**Cobra Motorcycle Mfg.**

## TSB2108 JR & OI Radiator Cap

July 9, 2008

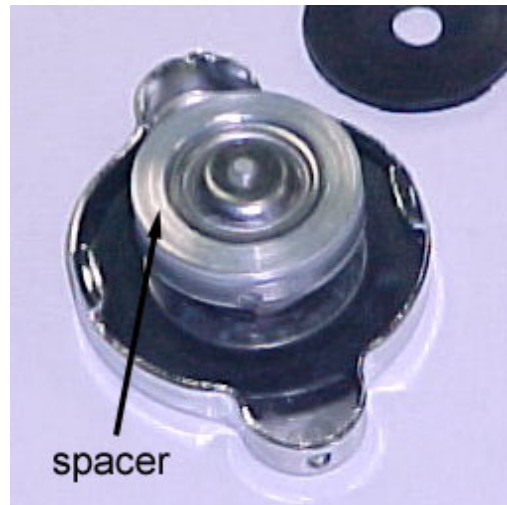
The radiator cap on the JR/OI radiators (Cobra part numbers; radiator only ECMU0225, or kits EKMU0007/EKMU0008) has a faulty pressure release point. Until the vender supplies us with properly functioning caps, the fix is to install a small shim under the sealing gasket on the cap (figure 1).

Cobra will send a spacer (ECMU0555) to all OI / JR customers with silver radiators. Assembly instructions are listed below. If the customer is uncomfortable with the installation process, they may send the cap to their dealer or back to the factory for installation.

1. Start the process by removing the rubber gasket. Stretch it to elongate the center hole (yes it will stretch a long way).

2. Once the gasket is stretched sufficiently, pull it back over the center crown to remove.

3. With the rubber gasket removed, place the spacer centered crown on the cap.

4. With the spacer in place, lightly pry up the center crown with a small screwdriver .
